Re: 2720 Ward St

Development Permit Application: DP-2020-00781

Permit #: **SW-2020-01541**

SUBJECT/MESSAGE: **2720 Ward St. – Sewer Servicing Information**

DRAWING #: M-0.1

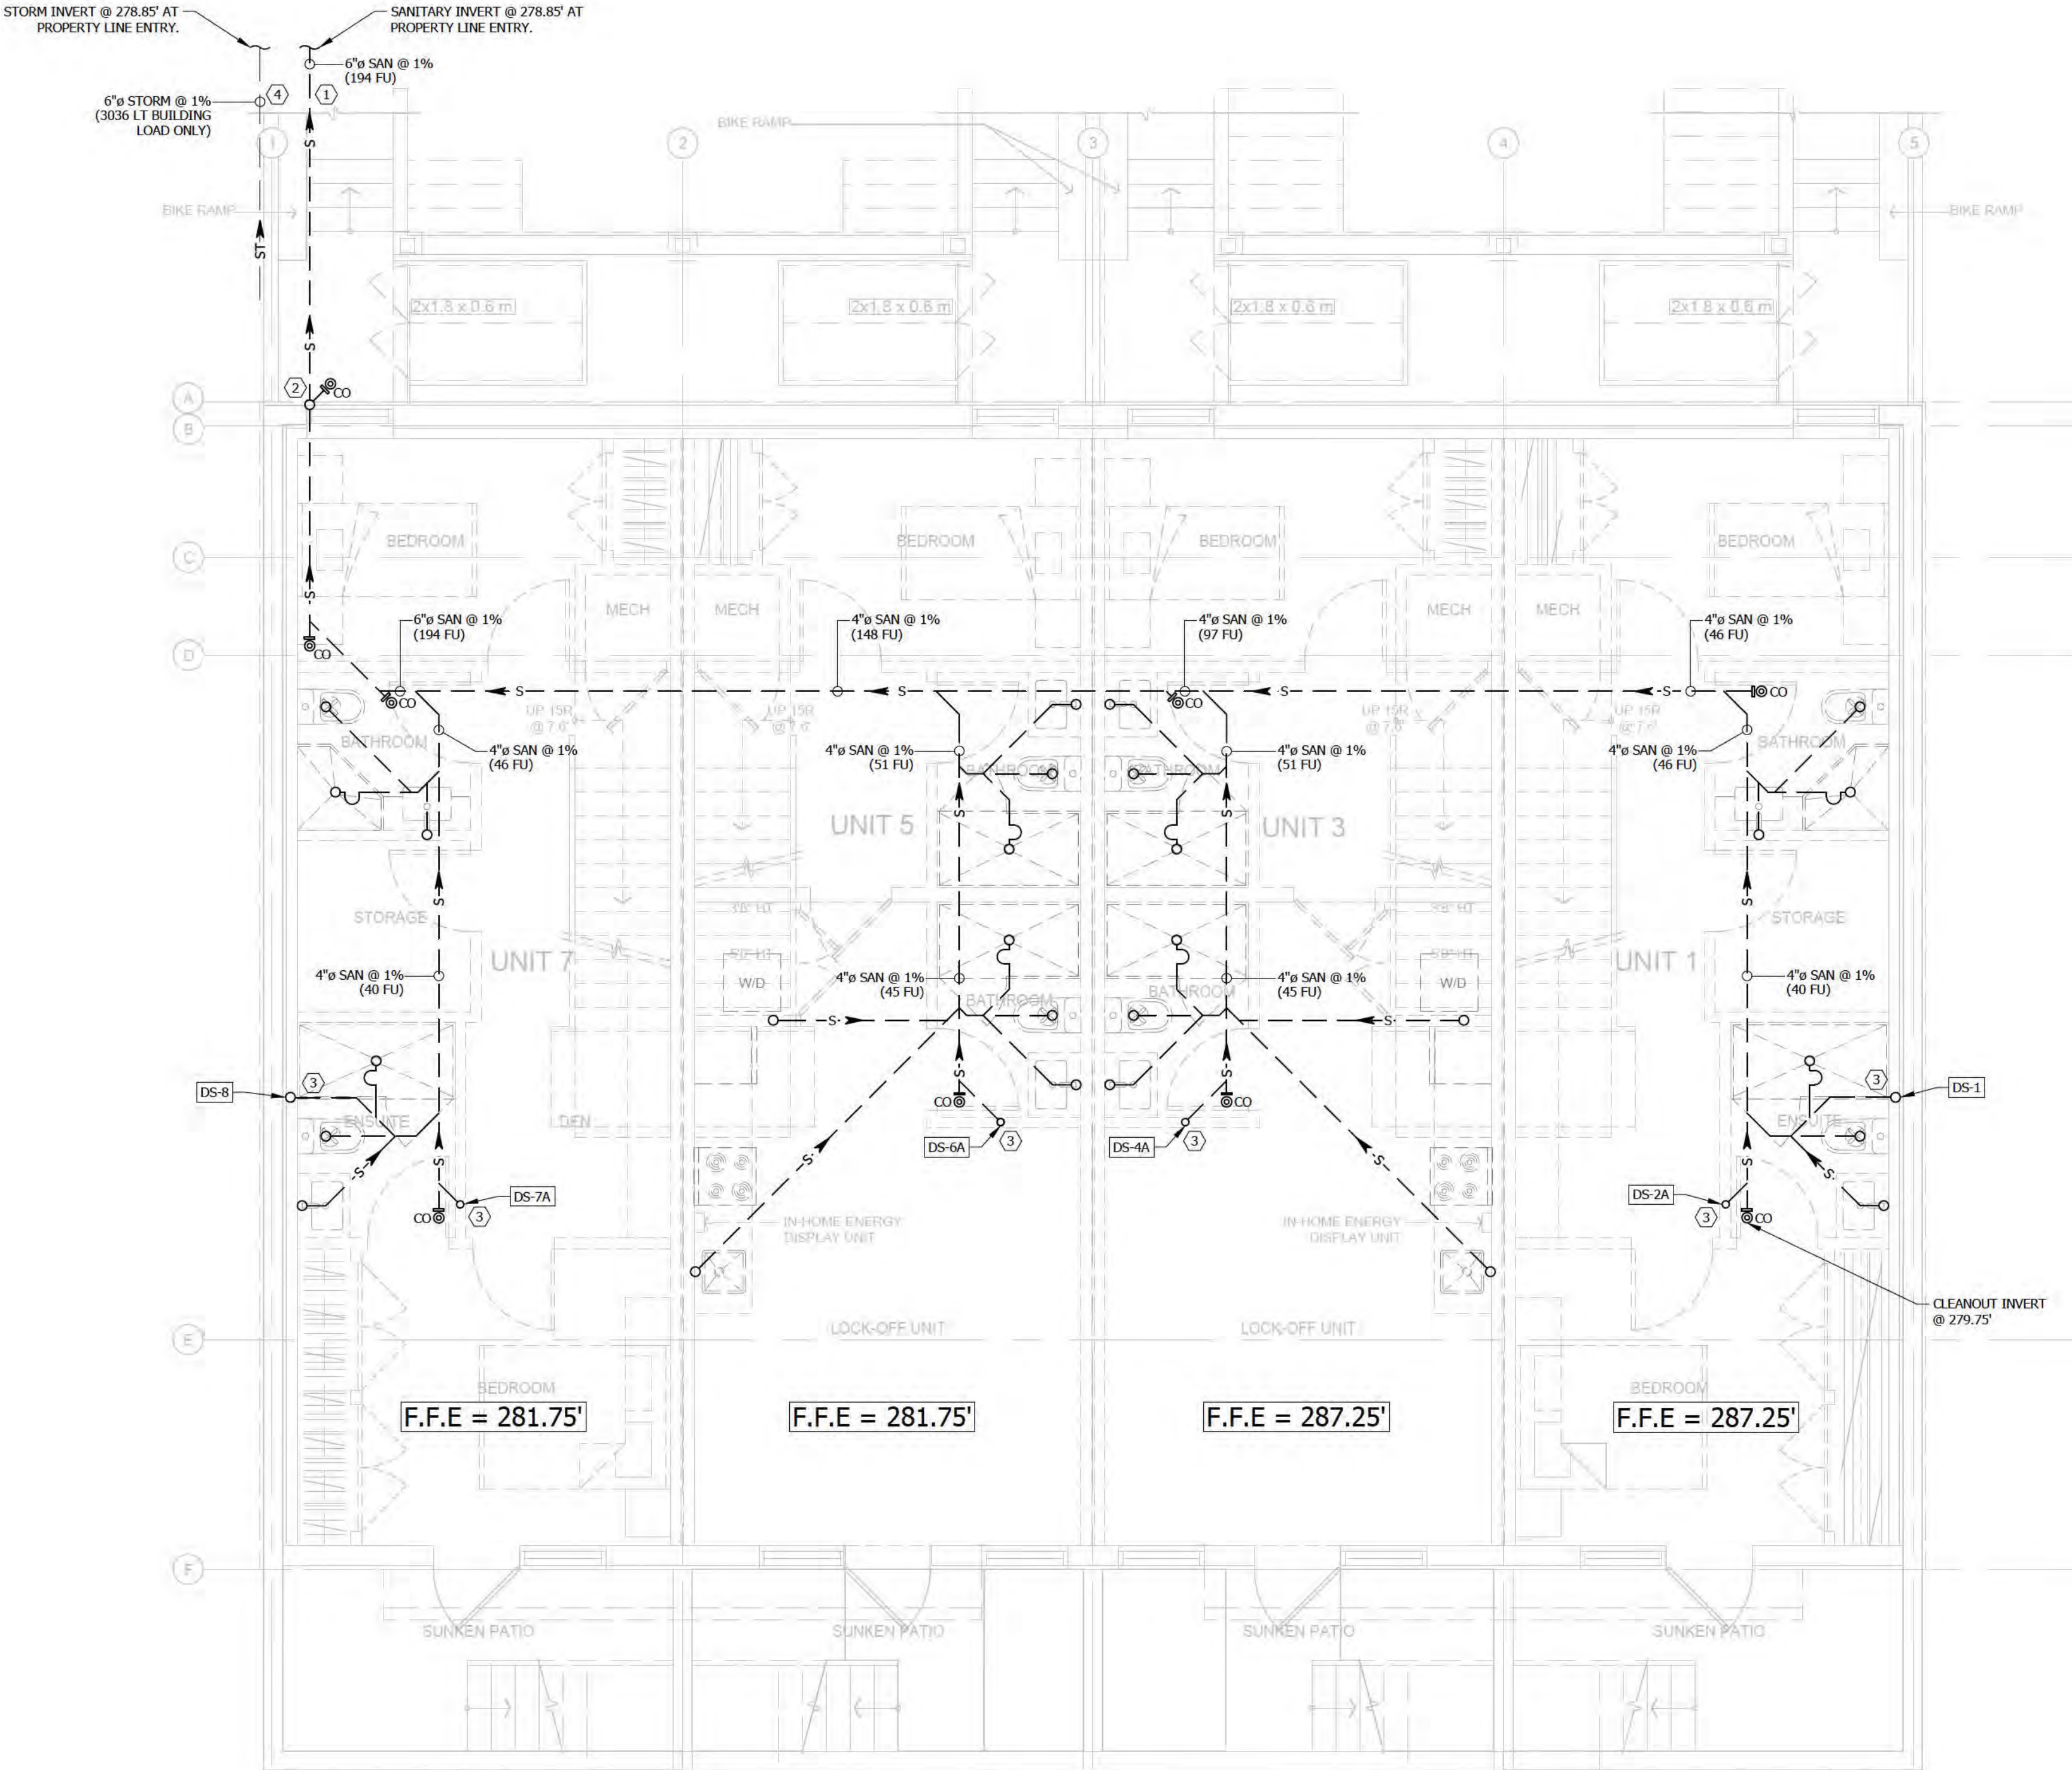
The proposed off-site sewer servicing information is attached. Please submit (email me directly) a sealed drawing for sewer permitting reflecting the attached information. The proposed service location and invert elevation at the property line on your drawing will require some slight adjustments.

Thank you for your response. We have prepared drawing showing sanitary lines on the west property line towards Ward St. Can you check if the drawing has all the required information

150mm Sanitary/150mm Storm Location = 1.00 meter east of the west property line to Ward St. This service location offset is to the middle of both pipes.

Please show 0.457 meters separation between the pipes at the property line (inside edge of pipe to inside edge of pipe).

The off-site sanitary and storm services will terminate at right angles at the property line.

The sanitary pipe will be to the left of the storm pipe when facing the property from the sewer mains.

Minimum Depth (invert elevation at the property line) = 85.96 meters.

Maximum Depth (invert elevation at the property line) = 85.09 meters.

The invert elevation of the sanitary and storm services must be the same at the property line.

Sanitary and Storm Fixture Restriction = 87.48 meters.
